**BROIL ELEMENTS**

**SOLID STATE RELAYS**  
 250V, 25A CONTACT RATING  
 3-32 VDC INPUT

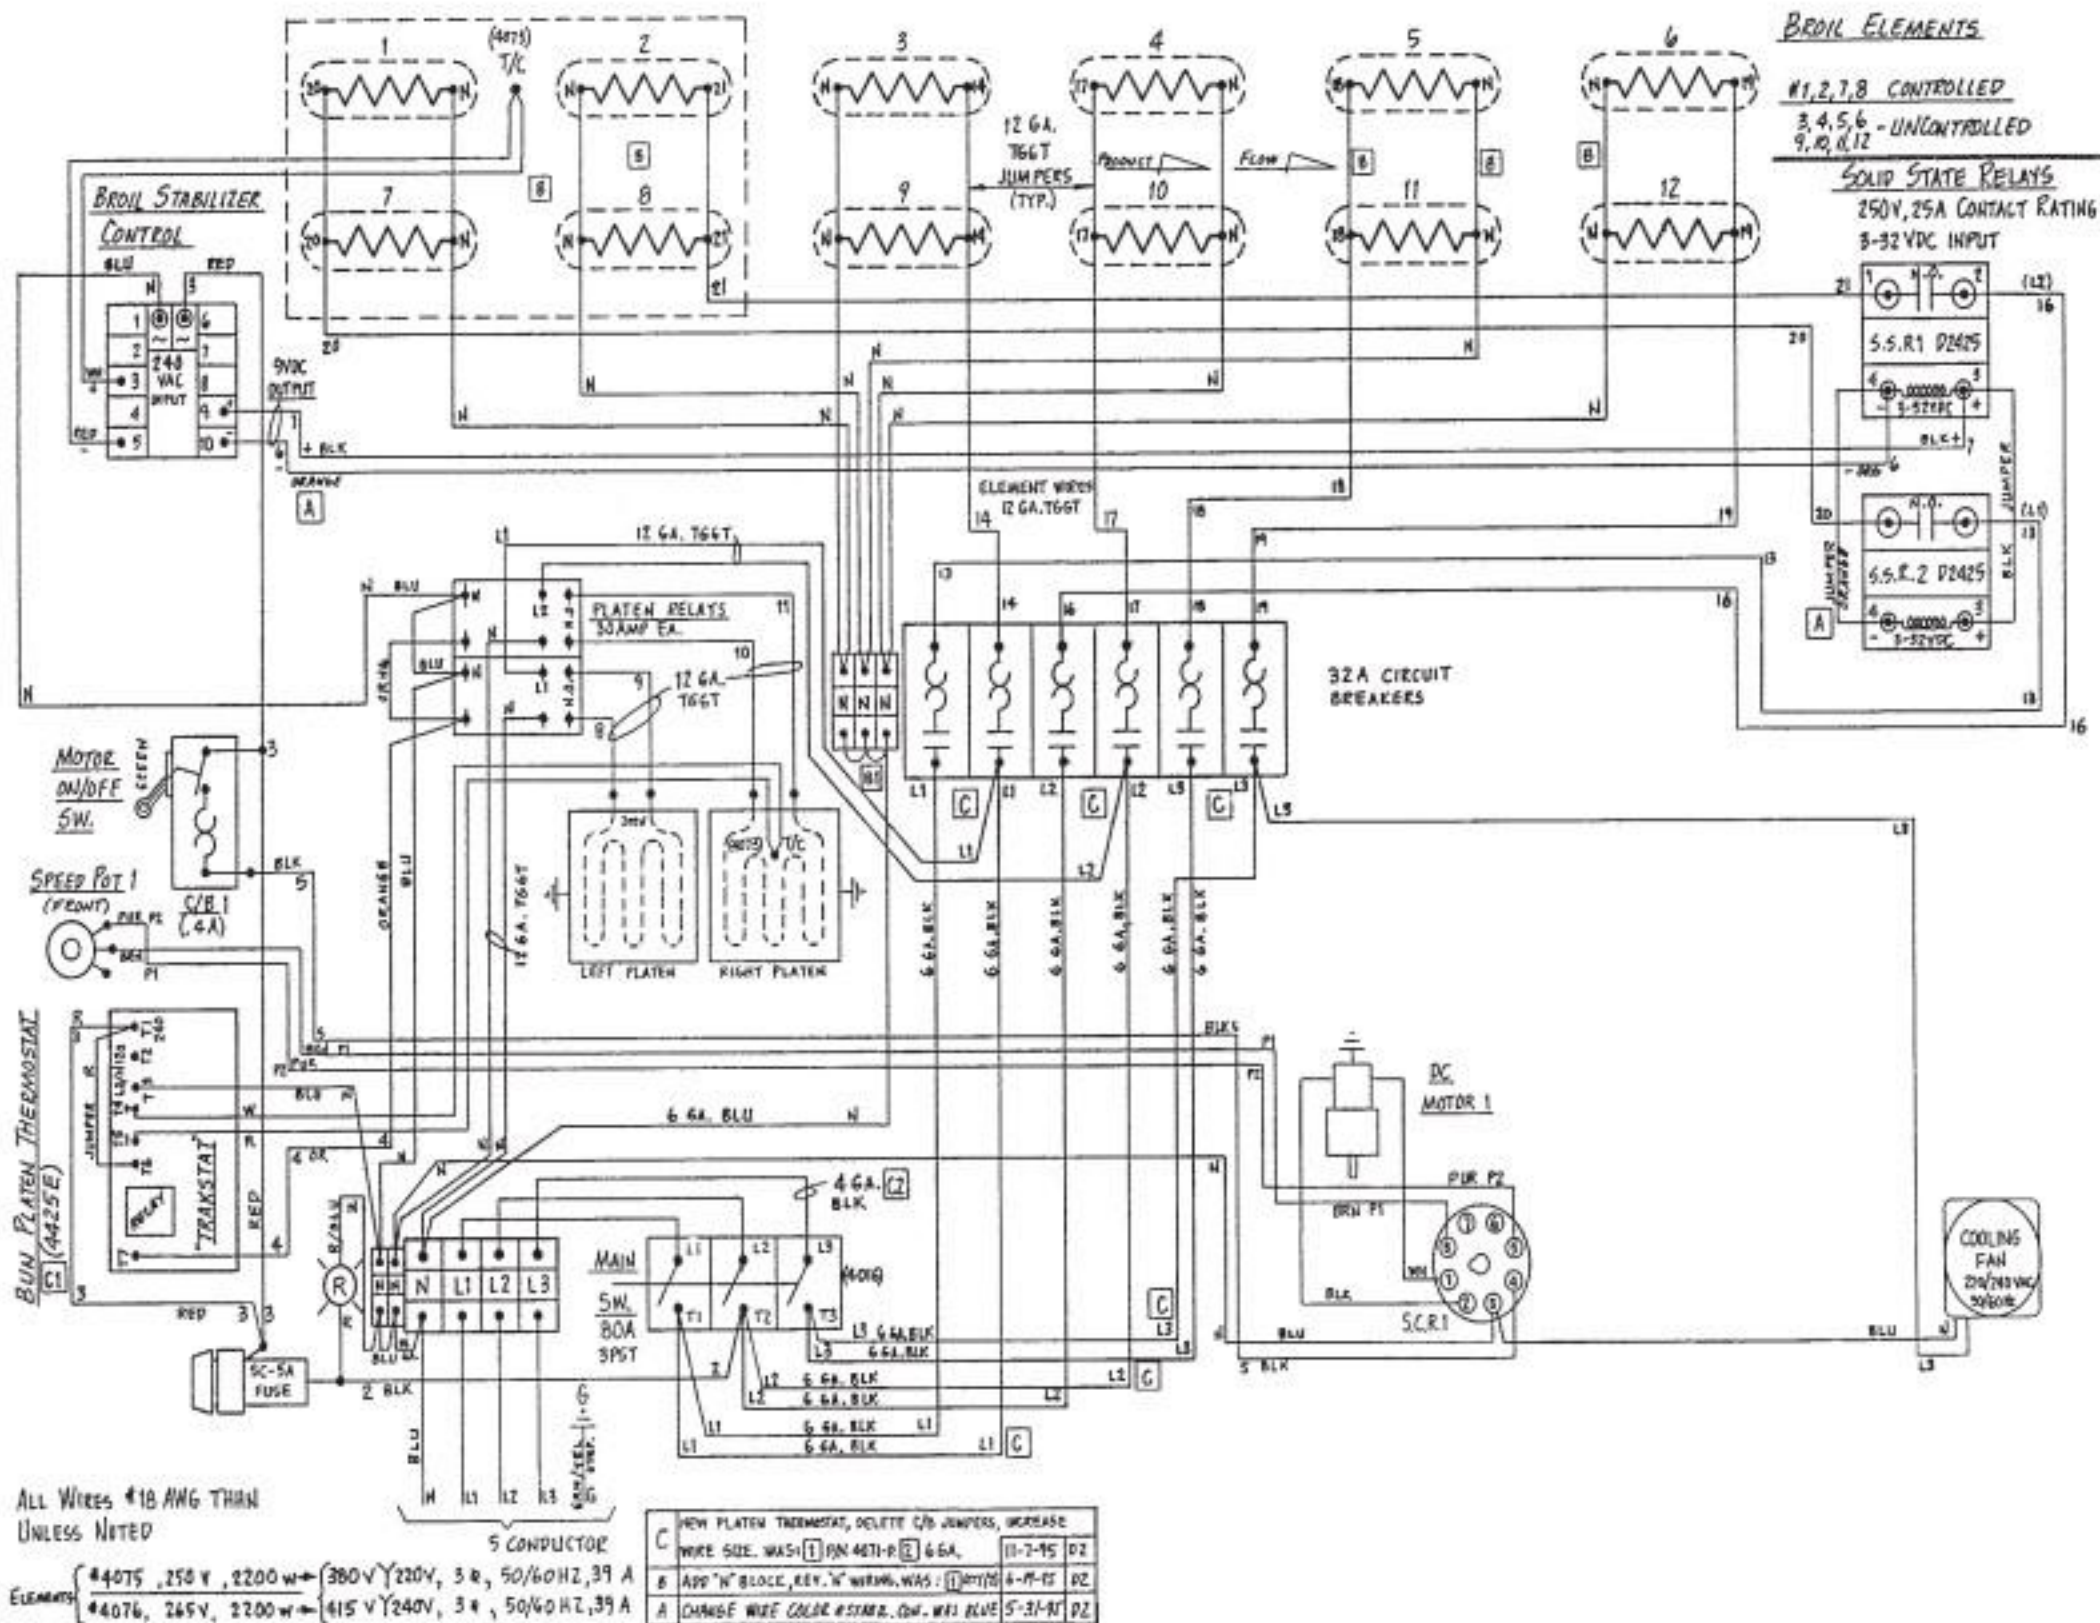
| C | NEW PLATEN THERMOSTAT, DELETE C/R JUMPERS, INCREASE WIRE SIZE WAS: (1) 18 AWG (2) 16 GA.       | 11-3-95 DZ |
| B | DELETE R/CPT, PWR. WIRE TO C/B; ADD (1) JUMPERS; CHANGE WIRE COND. WPS: (1) PERM. WTS (2) BLUR | 5-31-95 DZ |
| A | REVISE TERMINAL STRIP: ADD 'N' BLK                                                             | 5-10-95 DZ |

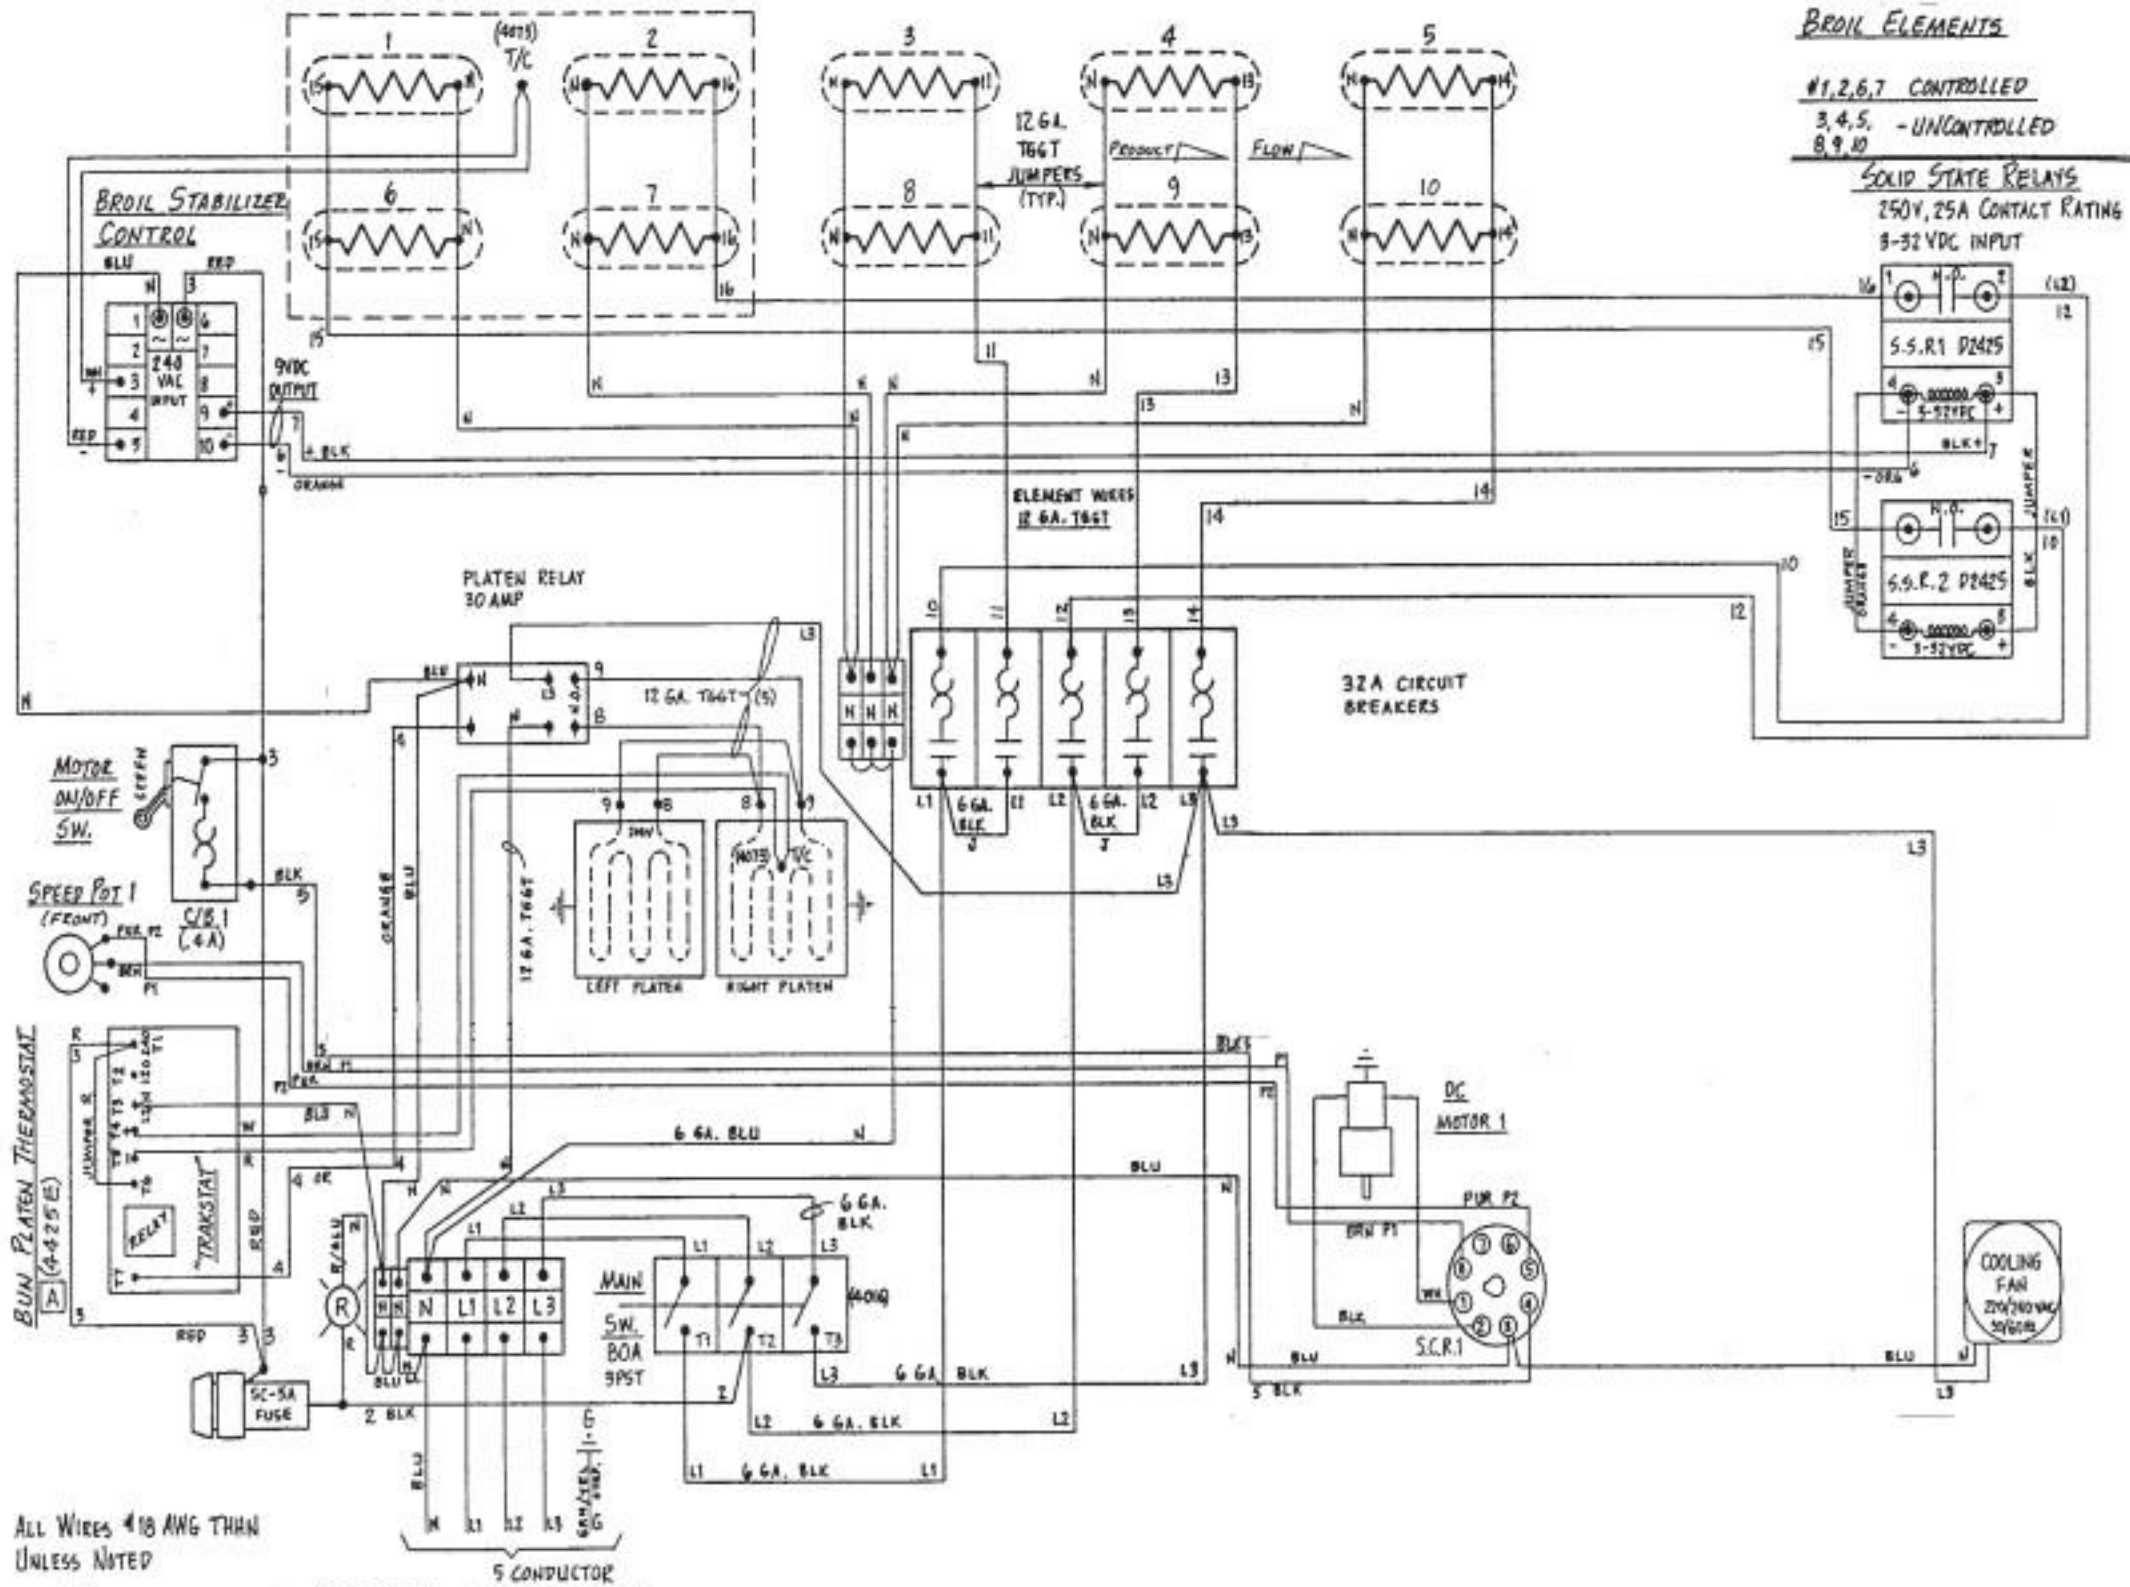
A NEW PLATEN THERMOSTAT, WAS P/N 4071-P 11-7-95 102

A NEW PLATEN THERMOSTAT WAS PIN 4071-P (11-7-95) PZ
